Division of Water Rights

August 30, 2011

We appreciated the opportunity of being involved in the meeting August 16, 2011, with the Washington County Conservancy District, Santa Clara Chairman, and New Castle representatives regarding management and distribution of the Grass Valley water and the trans-basin diversion tunnel. We came away from the meeting feeling it was productive towards resolving a long standing issue and encourage all parties involved to move forward in working out details of an agreement that will eventually be ratified by the involved parties.

1) Grass Valley Pond Outlet:

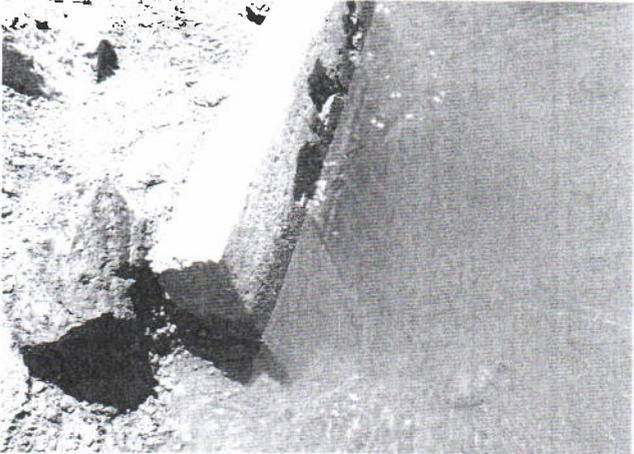
- 1) Grass Valley Dam & Outlet (see photos page 3)

Large rocks have been purposely placed in front of the grating, restricting free outflow from the reservoir. This is the second year this has occurred and previously it has been reported that plastic bags have been placed over this grating. As discussed in the meeting, some provision to prevent this from happening is warranted. A tower inlet structure could accomplish that purpose. Alternatively, water users may wish to consider breaching the structure since no controlled storage benefit appears to be occurring. A pre-runoff inspection should be done each year prior to the opening of the Santa Clara gate. If water is diverted and impounded, Dam Safety Requirements must be met.

2) Santa Clara Gate

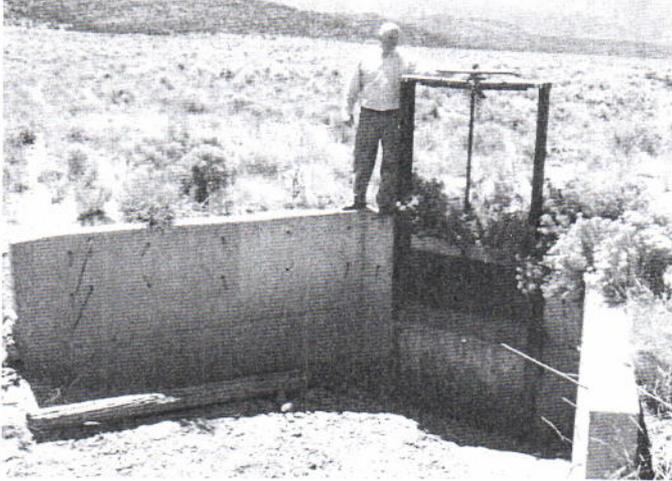
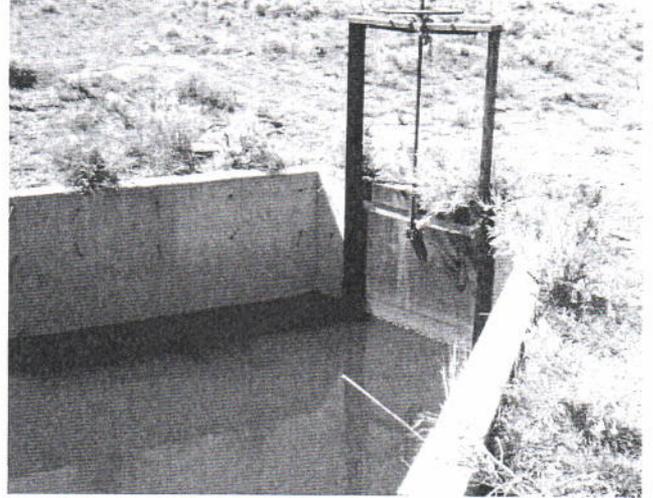
2) Santa Clara Gate (see photos page 4)

Effectiveness of the operation of the Santa Clara Gate at a range of flows is dependent on removal of the accumulated sand in front of the gate. Present conditions will allow only a portion of high flows through the gate once it is opened. The accumulation of sand must be removed to allow the gate to function as designed for all flow conditions. The best time to remove this sand accumulation is when the area is dry in the late summer or fall.
